## STATEMENT OF RESPONSE TO AN BORD PLEANÁLA PRE-APPLICATION CONSULTATION OPINION

Proposed Strategic Housing Development  
on Lands at Kilnahue & Gorey Hill,  
Carnew Road & Kilnahue Lane,  
Gorey, Co. Wexford

Applicant: Gerard Gannon Properties

March 2022

Figure 1. Indication of Net Density Calculation for the Proposed Scheme

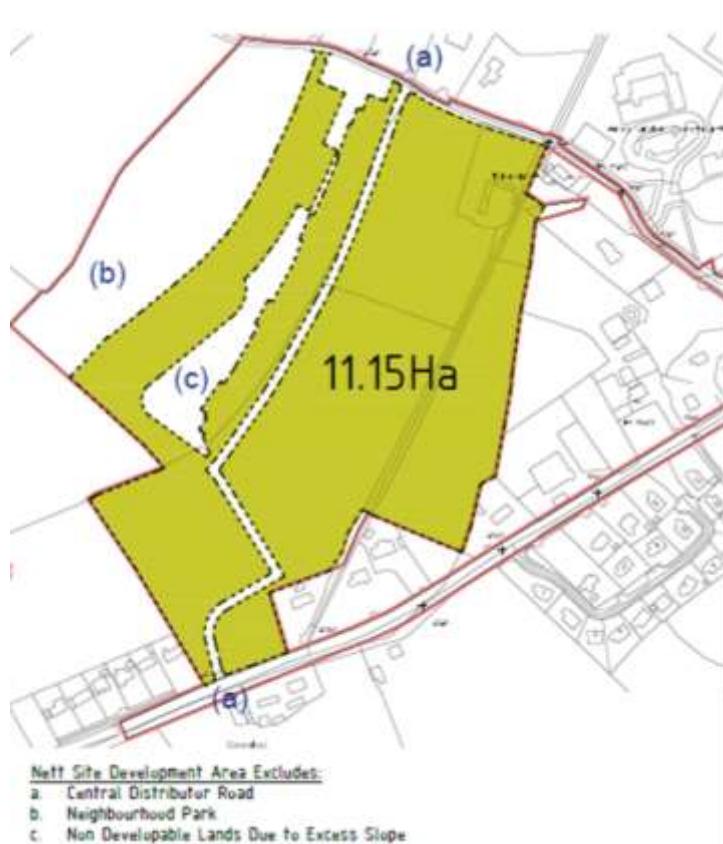
*"Further consideration/justification of the documents as they relate to the density in the proposed development and in particular that the proposed development is at a sustainable density to provide for an acceptable efficiency in serviceable land usage balanced with the requirement to respect the context within which the site is located. Particular regard should be had to the avoidance of residual open spaces within the site. The documentation should express density as a net figure and the calculation of same should accord with Appendix A of the Guidelines for Planning Authorities on Sustainable Residential Development in Urban Areas, 2009 in this regard and a drawing detailing the calculation of net density within the site boundary shall be submitted. The proposed development shall have regard to inter alia, national policy including the National Planning Framework, Urban Development and Building Heights Guidelines for Planning Authorities 2018, Guidelines for Planning Authorities on Sustainable Residential Development in Urban Areas, 2009 and Sustainable Urban Housing: Design Standards for New Apartments March 2018, local planning policy and the sites context and locational attributes and context. The further consideration of this issue may require an amendment to the documents and/or design proposal submitted relating to density and layout of the proposed development."*

Having taken account of the slope and topography of the site and its location on the edge of Gorey Town together with the ABP Opinion, the Stage 3 design proposes a higher density at 37.7 units per hectare. Excluding the Neighbourhood Park, central distributor road, and un-buildable/severely sloped lands, the development area stands at 11.15 hectares, and with respect to the overall proposed number of units at 421 dwellings, the density of 37.7 units per hectare would be achieved. This is consistent with HP08 of the Gorey Local Area Plan 2017-2023, and has been calculated as per the

- Overall Site Area: 19.17 ha
- Net Site Area: 11.15 ha
- Net Density:  $421 \text{ units} \div 11.15 \text{ ha} = 37.7 \text{ uph}$
